Bid#37-19
Market Street Gateway, Phase 2

Addendum #1
Issued: February 25, 2019

Addendum#1 clarifies questions that have been asked and adjusts the bid due date and final completion date.

SPECIAL PROVISION
AMENDMENT TO SECTION 616 - TRAFFIC SIGNALS

ATTACHMENT "A"

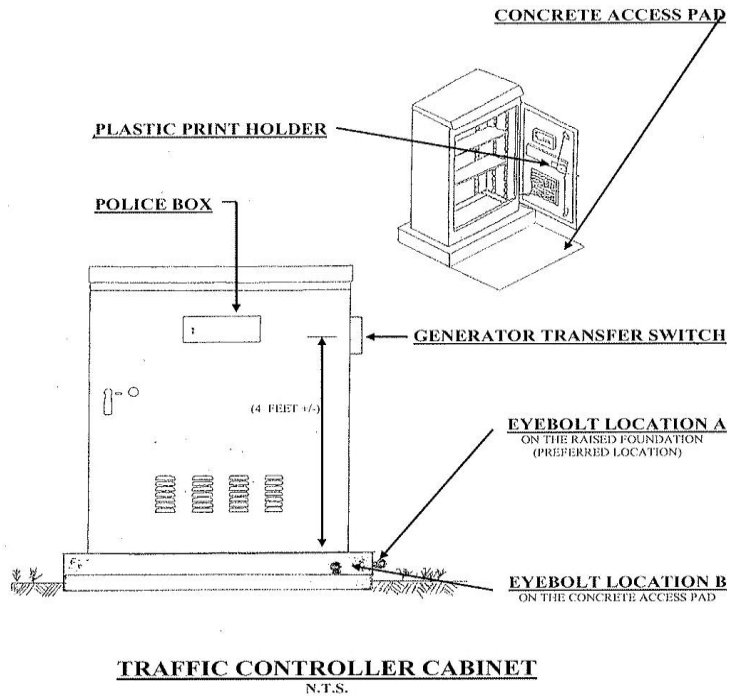
5. The Contractor shall install a generator anchoring system to the new traffic controller cabinet's cement concrete foundation. The location of the anchoring system will be on the side of the cabinet that houses the controller's power supply and installed to the minimum 12" raised concrete foundation (see location A on Attachment A Detail Plan). If the controller cabinet doesn't have a raised foundation to accommodate the anchoring system then the Contractor shall install the anchoring system to the front

access pad of the controller cabinet. The anchoring system shall be a ½-inch x 13 tpi galvanized wrought eyebolt with a thread length of 1 5/8-inch. The eyebolt shall be installed in a 5/8-inch diameter drilled hole into the concrete foundation or pad (the location of the drilled hole shall be placed in an area where it does not interfere with the existing controller cabinet anchor bolt system to the concrete foundation). The eyebolt shall be bonded into the concrete by an epoxy compound [Component “A” (105 resin) and Component “B” (205 hardener)], with the epoxy compound filling the drilled hole and covering the threads of the eyebolt. The epoxy compound shall be a product as included on the Department’s Qualified Product List. [See “Attachment A” Detail Plan]
